TITLE : AIR CONDITIONING - PACK TEMPERATURE CONTROL - MODIFY PACK TEMPERATURE

CONTROLLERS 7HH AND 27HH

This page transmits Revision No. 03 of Service Bulletin No. A320-21-1082.

DATE : Feb 04/94 SERVICE BULLETIN No. : A320-21-1082

Modification to the Wiring in R Electronics Rack 95VU and 96VU Figure 3 Sheet 1

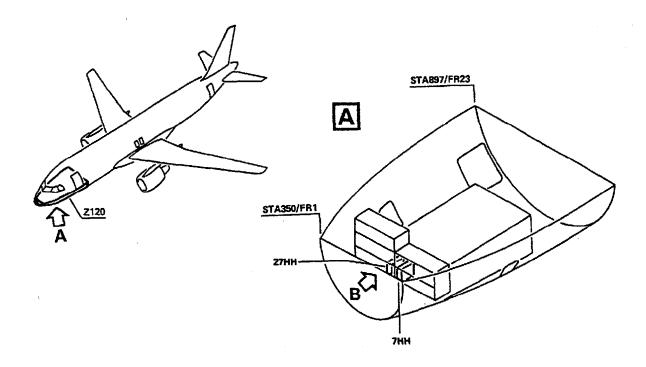
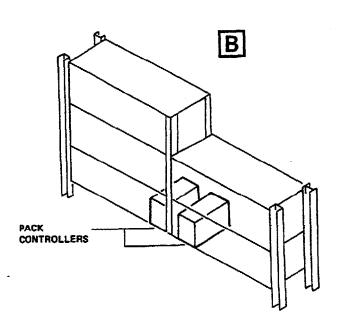
Refer to the wiring diagram Figure 3 and the Hook-Up Chart Figure 4.

- (a) Do the modification to the wiring in electronics rack 95VU and 96VU.
 - 1 To get access to the modification area remove and store items of equipment from the electronics rack 95VU and 96VU.

<u>5</u> Do the routing of the wires shown on lines 1 and 2 of the Hook-up Chart, Figure 4 and supplied in:

- 7 Cut the wires to length, crimp the terminals and connect as given in the Hook-up Chart, Figure 4.
- 8 Install the shelves removed for access with the retained attachment hardware, Refer to Paragraph 2.B.(2)(a)4.

Component Location of the Pack Temperature Controllers 7HH and 27HH Figure 1 Sheet 1

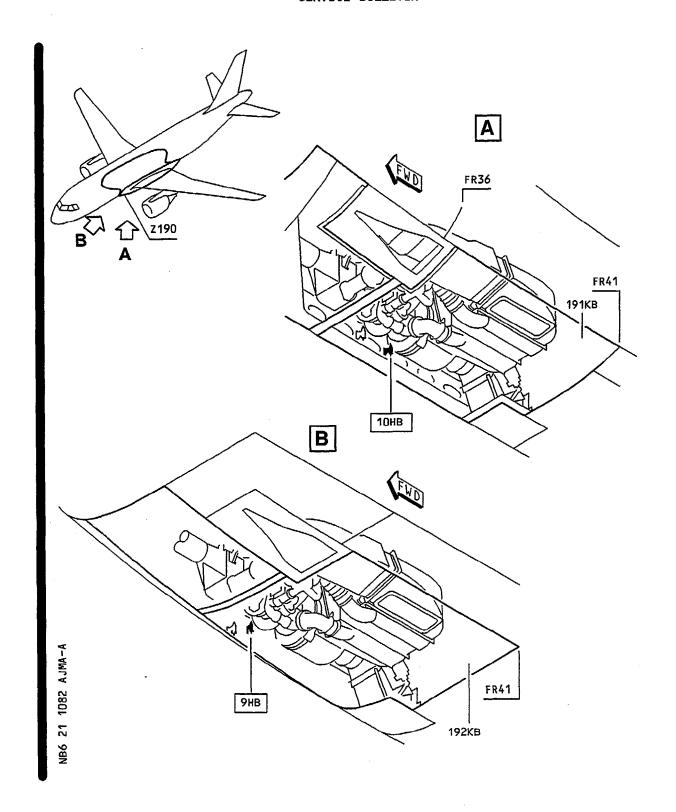
Refer to Figure 1 and 2.

- (a) Remove the pack temperature controllers 7HH and 27HH. (Refer to AMM 21-61-34, P. Block 401).
- (b) Do the modification to the pack temperature controllers 7HH and 27HH as given in Liebherr/ABG-Semca Service Bulletin No. 759A-21-06.
- NOTE: The Pack Temperature Controller 759A0000-08 used with the Sensor 768A0000-03 can be replaced by the Pack Temperature Controller 759A0000-10 when the pin BC7 of the Pack Temperature Controller is connected to the aircraft electrical ground at the connectors 7HH-A and 27HH-A.

Component Location of the Flow Sensors, 9HB and 10HB Figure 2 Sheet 1

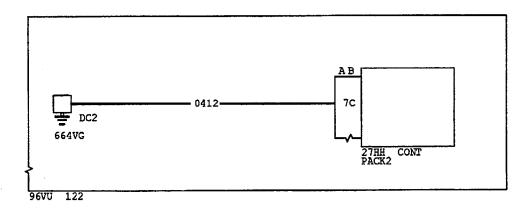
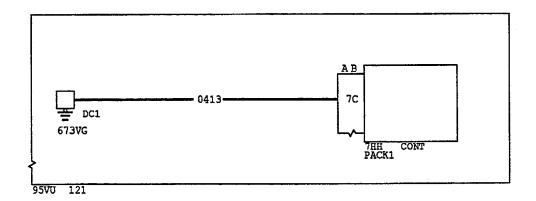
Worksteps and a new figure to show the Flow Sensor 9HB and 10HB, locations added.
